Final Environmental Impact Report

El Dorado Forebay Dam Modification Project

State Clearinghouse No. 2013032036

FIGURE 2

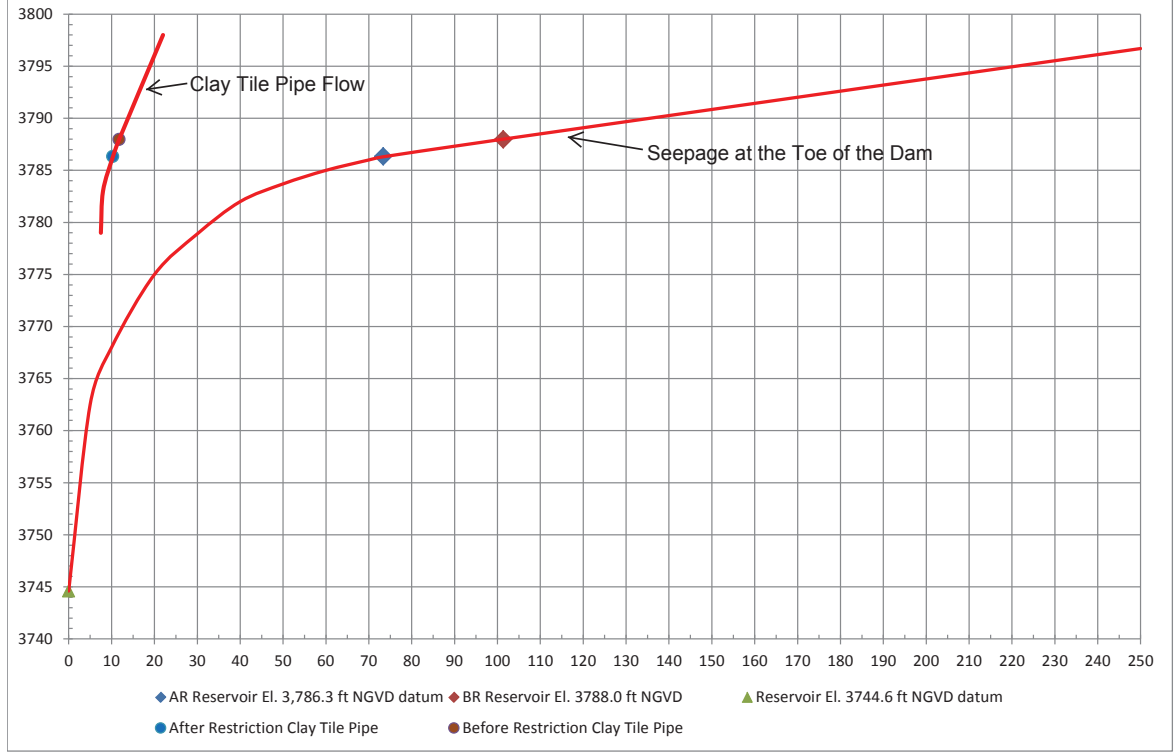
Please provide information regarding the water quality of the dam seepage. State Water Board staff is interested in whether the dam seepage has constituents of concern, such as elevated levels of iron or mercury. Additionally, please provide information regarding the magnitude of water that currently seeps from the dam versus the amount of predicted seepage once the seepage pump facility is replaced. Please detail the specific impacts associated with the decrease in seepage due to pumping, such as the expected acreage of lost wetlands habitat or riparian cover downstream.

5-6 GEI Consultants, Inc., conducted a study to characterize the seepage flows from the Forebay Dam in the current and future configurations (GEI 2014). This analysis is included in Appendix C of this document. The analysis utilized previous seepage analyses and measurements from weirs located below the toe of the dam to characterize existing surface/subsurface seepage flows and to project seepage flows to Long Canyon Creek after the dam modification project is complete. The dam modification and raise would induce higher seepage gradients on the dam, foundation, and abutments, as well as submerge a larger area of the reservoir rim. This would increase the amount of seepage below the dam. The reconstructed seepage pump-back station is designed to handle this additional seepage and return it to the EID water system. Under the current conditions (restricted reservoir), flows to Long Canyon Creek are estimated to be 60 gallons per minute (gpm). After the dam is modified, flows to Long Canyon Creek are estimated to be 60 gpm as well. Based on GEI's analysis, the proposed dam modifications would not have an effect on the magnitude of water flows to Long Canyon Creek.

The curves shown on **Figure 2** plot the average seepage flows at the reservoir levels for which seepage measurements are available and extrapolate the seepage flows up to the anticipated maximum future reservoir level. For an estimated future average reservoir operating level at El. 3,795 NGVD, the estimated seepage reporting to the weirs at the downstream toe of the dam would be on the order of 220 gpm, and the estimated clay tile pipe flow would be on the order of 20 gpm.
